DATE: July 15, 2015

AGENDA ITEM # 3

TO: Design Review Commission
FROM: David Kornfield, Planning Services Manager
SUBJECT: 15-V-08 & 15-SC-24 – 55 Doud Drive

PROJECT DESCRIPTION

P-1, right: subject coast redwood tree looking toward street.

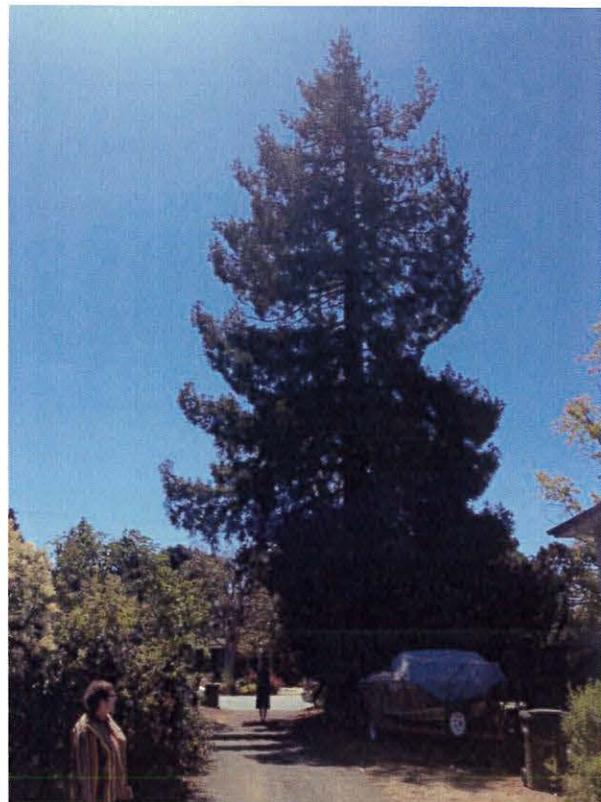
In order to get to this new home, the driveway entering from Doud Drive must pass very near alongside this 47-inch diameter coastal redwood tree (*Sequoia sempervirens*).

Team Abigail has already been in contact with fire department officials to preview width of opening needed for emergency vehicle access past this tree, and they are willing to allow a variance from typical 14- to 12-feet.

4.2 Recommendations: This project should be allowed to move forward as planned by the Team Abigail – running the new driveway alongside this subject redwood tree per the discussion above.

3.1 Tree Location on preliminary map:

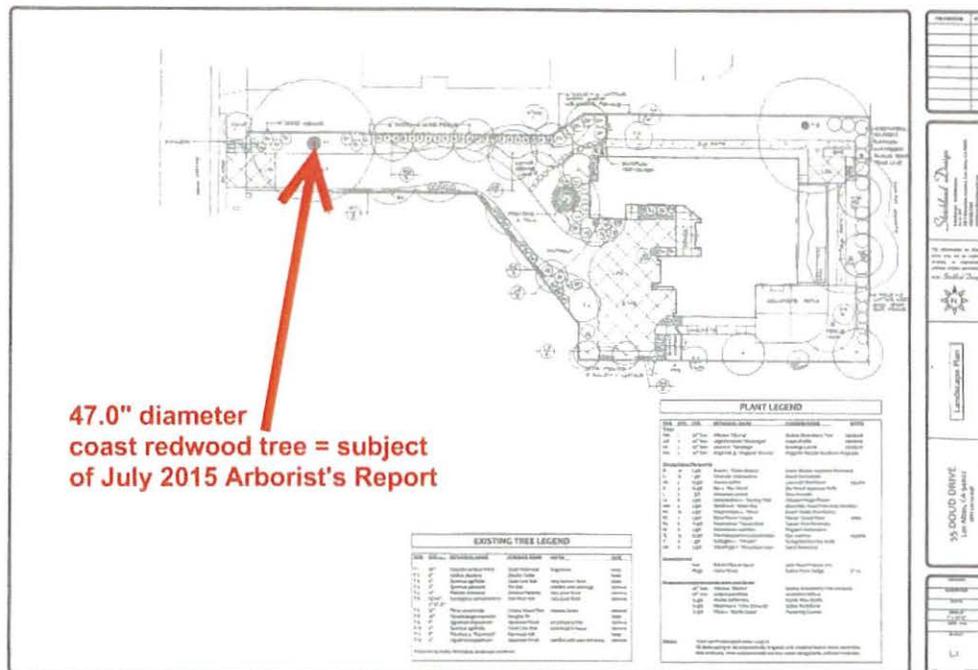
coastal redwood tree	<i>Sequoia sempervirens</i>
47.0"	dbh = diameter at standard 54-inches
~115'	height (estimated)
20'	foliage crown radius
65% (Fair)	vigor rating
75% (Good)	structure rating
70% (Good)	overall condition rating
upper crown status?	no notable dieback, but topped at ~100-feet.
root flare	good (visible and intact – burl with sprouts)
surface roots?	visible as slight mounding ... slight ridging crossing into existing dirt/gravel driveway.
13' opening width	13' between root flare and existing brick column (see photo P-2, below)
3' distance to existing driveway	3' from root flare to (e) dirt driveway wheeltrack
33' BOC (back of curb)	measured distance to rolled curb at street

4.1 Conclusions: Using asphalt on existing grade beneath this tree’s foliage canopy, then pavers beyond the dripline, is the favored construction method for this tree on this site
